From: FREGONESE, Victor <vxf@nei.org>
Sent: Wednesday, April 26, 2017 2:23 PM
To: Drake, Jason
Cc: Morton, Wendell; Rahn, David; GEIER, Stephen; REMER, Jason
Subject: [External_Sender] NEI Comments on Draft RIS and Draft Qual Assessment Guidance
Attachments: Draft_RIS_to_Clarify_RIS_2002-22_04-20-2017 Meeting Copy [NEI Comments 4-26].docx; Qualitative Assessment Guidance 04-20-2017 Public Meeting Copy [NEI Comments 4-26].docx

**NRC REGULATORY ISSUE SUMMARY 2017-XX
UPDATE TO THE STAFF ENDORSEMENT ON THE USE OF
EPRI/NEI JOINT TASK FORCE REPORT,
“GUIDELINE ON LICENSING DIGITAL UPGRADES: EPRI TR-102348,
REVISION 1, NEI 01-01: A REVISION OF EPRI TR-102348 TO
REFLECT CHANGES TO THE 10 CFR 50.59 RULE”
(REPORT PREVIOUSLY ENDORSED ~~BY~~ **WITHIN** RIS 2002-22)**

Draft – Qualitative Assessment Framework

Figure 1 - RIS Decision Tree Flowchart

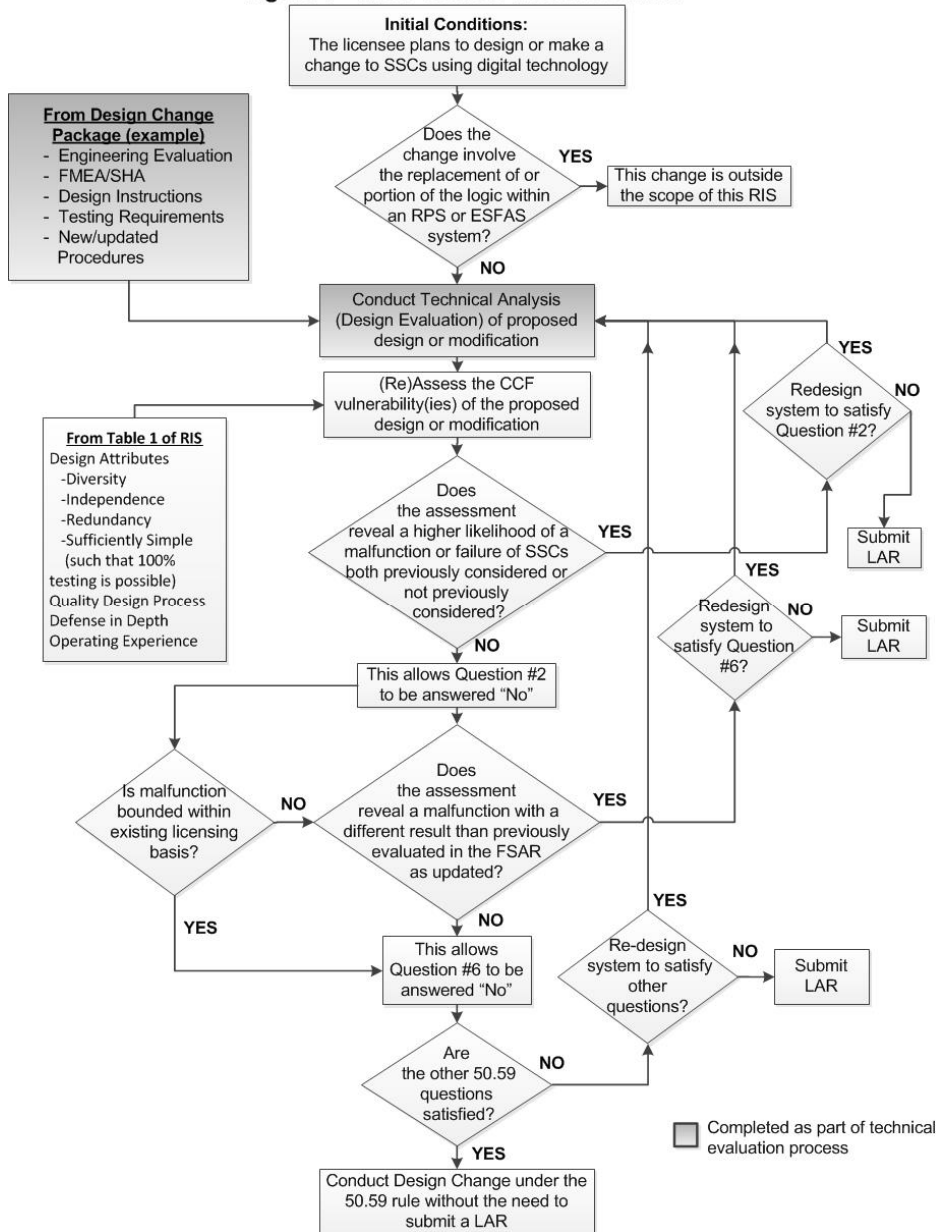
Commented [vxf26]: There is no box for 50.59 Question #6.

Commented [vxf27]: Many of the "rectangles" on the flow chart do not have a "yes" or "no". For instance, the box that contains "This allows Question #2 to be answered NO". Please clarify this in the flowchart.

Commented [vxf28]: Please refer to previous comment on the 100% testability in Table 1.

Commented [vxf29]: Please clarify what the purpose of the decision block that states: "Is malfunction bounded within the existing licensing basis?"
